<b>TempNo.</b>	<b>PI</b>	<b>Topic</b>	<b>Status</b>	<b>Plant/ Co.</b>
76.0	IE03	Discovery of an Off-normal condition	1/16 Introduced and discussed 2/20 Discussed 3/19 Discussed 4/16 Tentative Approval	Quad Cities

FAQ 76.0

Performance Indicator: Unplanned Power Changes per 7,000 Critical Hours

Attachment 2

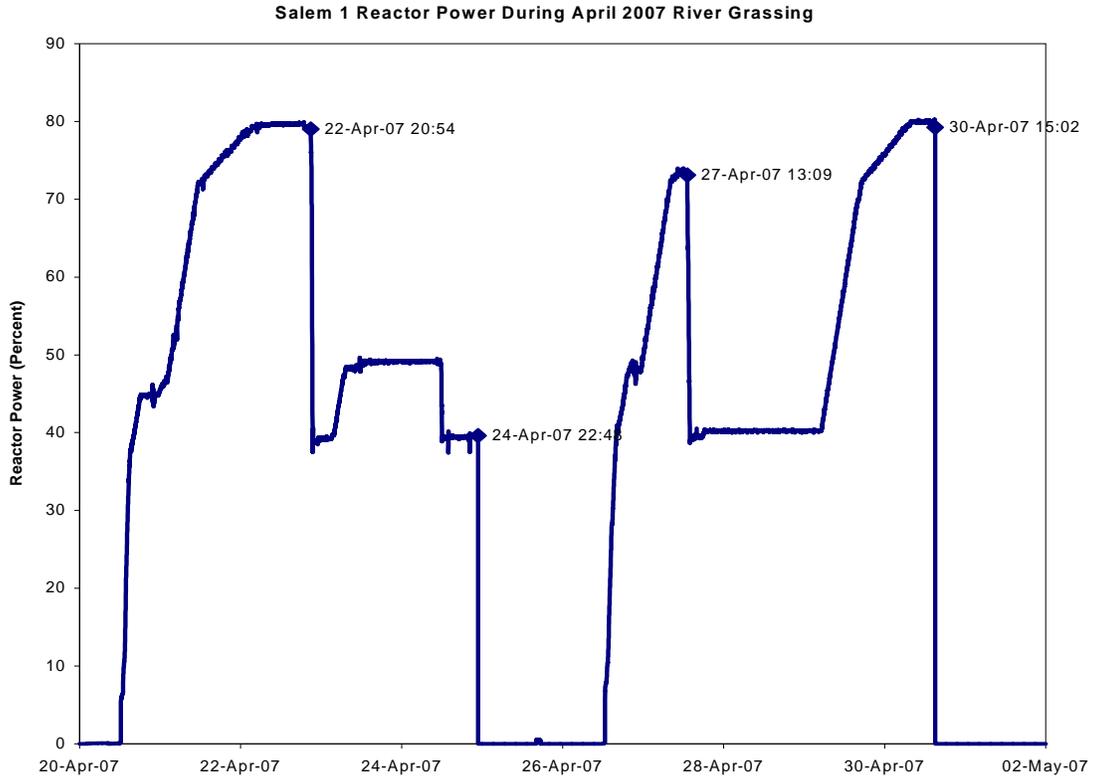
On April 20, 2007 Salem Unit 1 began its return to power from its 18<sup>th</sup> refueling outage. During the power ascension, circulating water pumps were being removed from service in accordance with procedures to clear the traveling water screens and to clean the condenser water boxes of debris. On April 22, 2007 a power level of 80% was reached. A greater than anticipated influx of marine debris/grassing occurred causing circulating water pumps to be shutdown. The delta temperatures across the condenser began to increase and power was reduced to approximately 40% power in accordance with abnormal operating procedures to maintain condenser outlet temperatures below established limits. When monitoring and predictions indicated a reduced grass level, power was increased to 48% on April 23, 2007 where it remained for approximately one day for continued monitoring of grassing levels. On April 24, 2007 grass levels increased again requiring a downpower to 40%. Late on April 24, 2007 Salem Unit 1 was manually tripped by procedure due to the tripping of several circulating water pumps as a result of an influx of marine debris/grassing. [This was counted as a reactor shutdown] (See Attachment 2 for Power-History curve)

The downpowers were caused by environmental conditions, beyond the control of the licensee, which could not be predicted greater than 72 hours in advance. Procedures were in place to address this expected condition; however, the magnitudes of the grassing events were unique in severity. The licensee had taken all reasonable actions to proactively prevent the downpower, and all equipment was maintained and operational. Therefore, these downpowers do not count against the performance indicator.

The charts below summarize the key data. They include three plots:

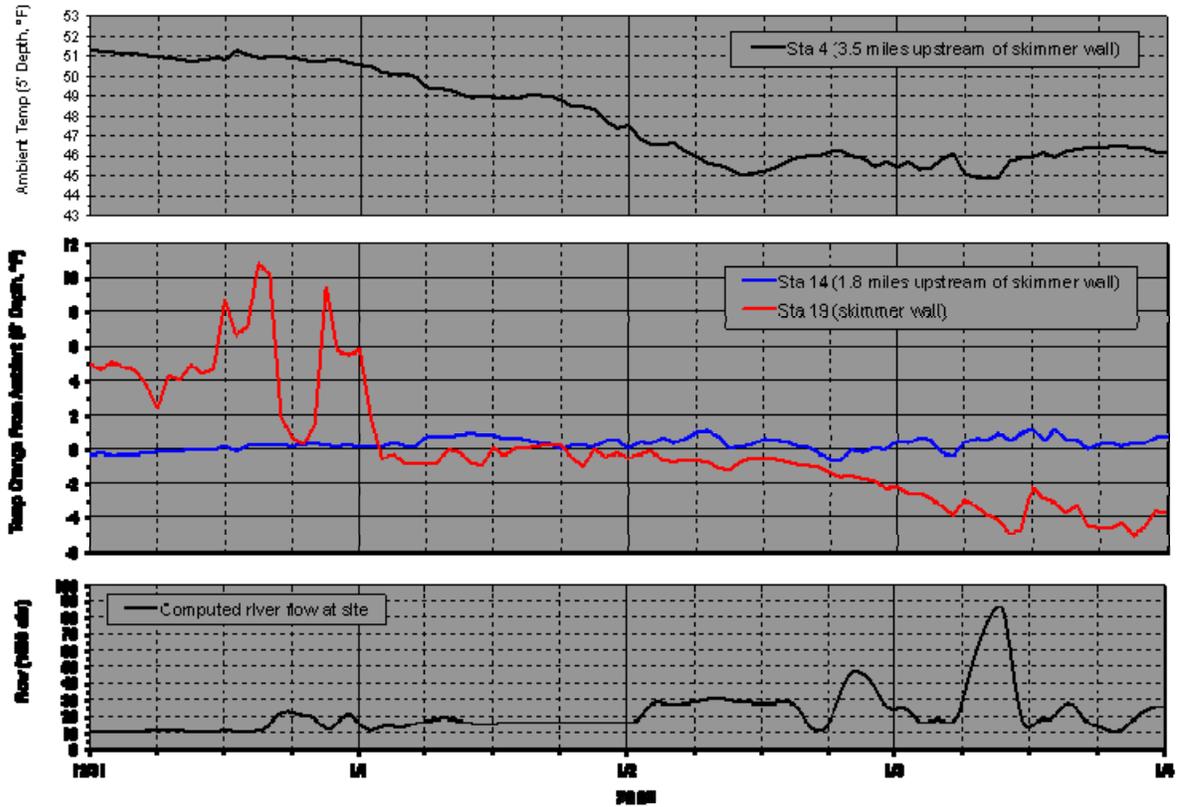
Late in the day on January 2, 2008, hydro peaking operations produced peak river flows near 47,000 cfs, lowering the water temperature at Station 19 (i.e., intake skimmer wall) 2°F below the ambient temperature. Late in the morning on January 3, 2008, hydro power peaking operations produced peak river flows near 87,000 cfs, lowering the water temperature at Station 19 another 2°F (a total of about 4°F below the ambient temperature). In these events, the water entering the skimmer wall is below the ambient temperature because at high river flow, the plant withdrawal zone encompasses primarily the shallow overbank areas upstream of the intake. For extreme cold meteorology, the temperature of the water in these shallow areas will be colder than in the main channel of the river. At this point, however, the shad were probably already lethargic (due to the larger drop in temperature between late December 31, 2007 through January 2, 2008).

The downpowers, caused by environmental conditions and National Pollutant Discharge Elimination System (NPDES) restrictions for plant thermal discharge, were beyond the control of the licensee and could not be reasonably predicted greater than 72 hours in advance.

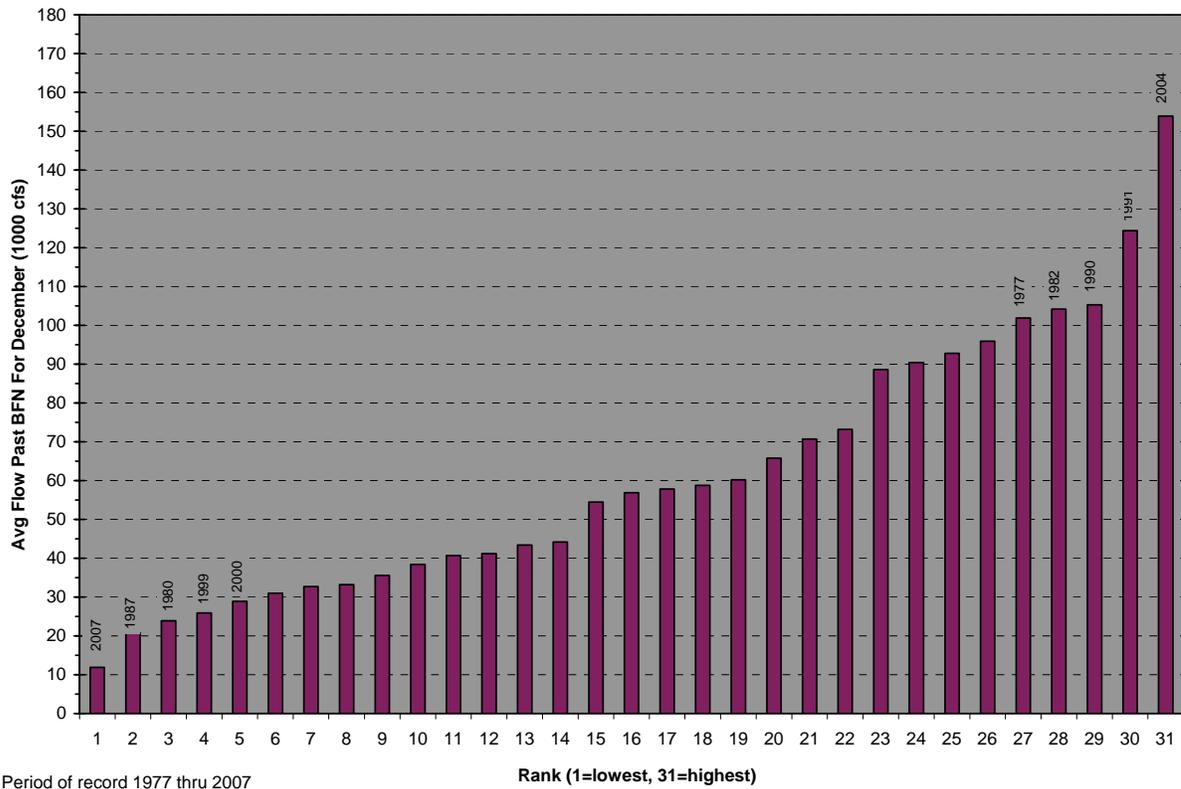
The drought conditions that existed in the Tennessee Valley during 2007 were most likely a contributing factor in the shad event. The drought conditions in the area were more severe this past year than any time previous in Brown Ferry's operational experience. River flows in the months preceding the event were well below normal. For example, the average river flow past the plant in December 2007 was the lowest in 31 years (see below).

In combination with the waste heat from the plant diffusers, this low flow would have created a larger than normal warm water sanctuary for the shad (e.g., because of low river flow, less heat was flushed downstream) establishing the conditions for a thermal shock event to occur.
